Technical Service Bulletin

26 Droning, buzzing, or vibration in Q7 3.0TFSI

26 19 34 2054935/1 May 6, 2019.

Model(s)	Year	VIN Range	Vehicle-Specific Equipment
Q7	2017 - 2018	All	3.0TFSI

Figure 1. Exhaust hanger "A" and decoupling element "B".

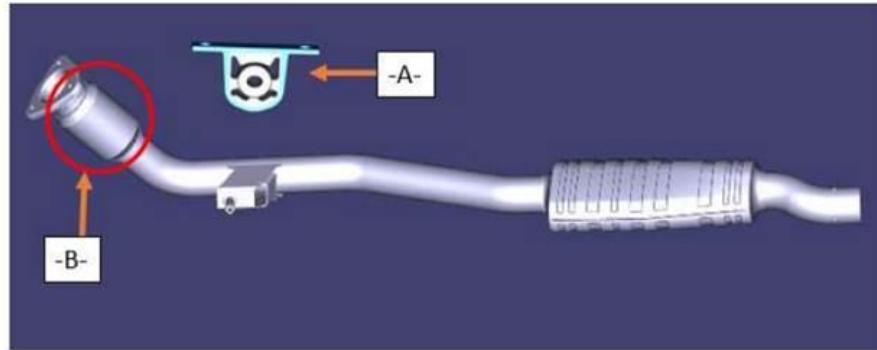
Over time, the exhaust decoupling element may become worn and ineffective.

Vehicles in production receive improved exhaust hangers to reduce NVH. These parts are now available in service.

1. Verify exhaust downpipes as the source of the customer concern.
2. Replace both exhaust downpipes (“exhaust pipe with exhaust muffler, front”) and exhaust hangers (“bracket for exhaust pipe”) with the part numbers outlined below (or any future supersession thereof).
